Product Change Notification

Product Group: SIL/Friday July 31, 2026/PCN-SIL-061-2026-REV-0

Commercial Power MOSFET Manufacturing Capacity Expansion for D2PAK (TO-263-7L) Package

VERSION 2: FACILITY CODE = N

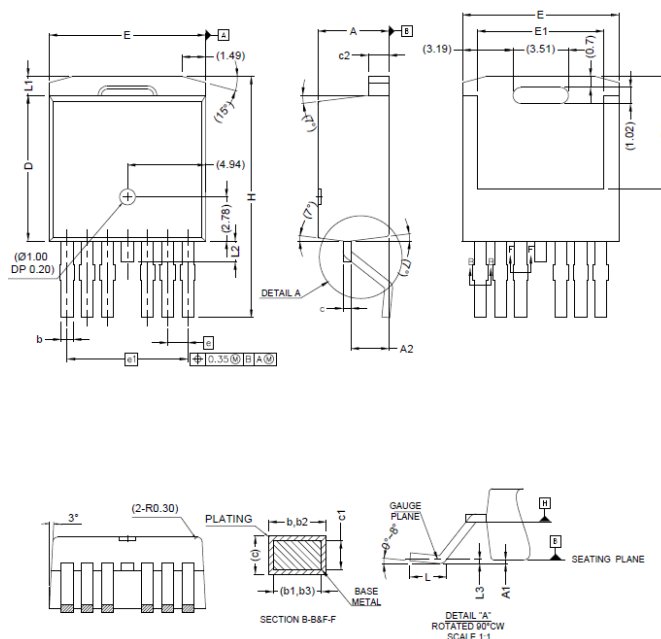
Expected Influence on Quality/Reliability/Performance: There will be no effect on the quality, reliability, and performance; no changes in minimum and maximum values on the datasheet parameters. PAD Pattern are compatible while the package drawing and outlooking will follow the official document Doc#63782, "D2PAK (TO-263-7L) Case Outline".

Product Identification: Products manufactured at ATX will be identified by the factory code "N" on the top-marking.

FACILITY CODE = N		(unit: mm)
DIM.	MIN.	MAX.
A	4.30	4.70
b	0.65	0.85
b1	0.65	0.80
c	0.45	0.60
C1	0.45	0.55
C2	1.25	1.40
D	9.00	9.40
D1	6.86	7.42
D1	6.86	7.42
D2	-	1.02
D3	-	0.7
E	9.68	10.08
E1	7.70	8.30
E2	-	3.51
E	1.27 BSC	
H	14.61	15.88
L	1.78	2.79
L1	-	1.60
L2	-	1.78
L3	0.25 BSC
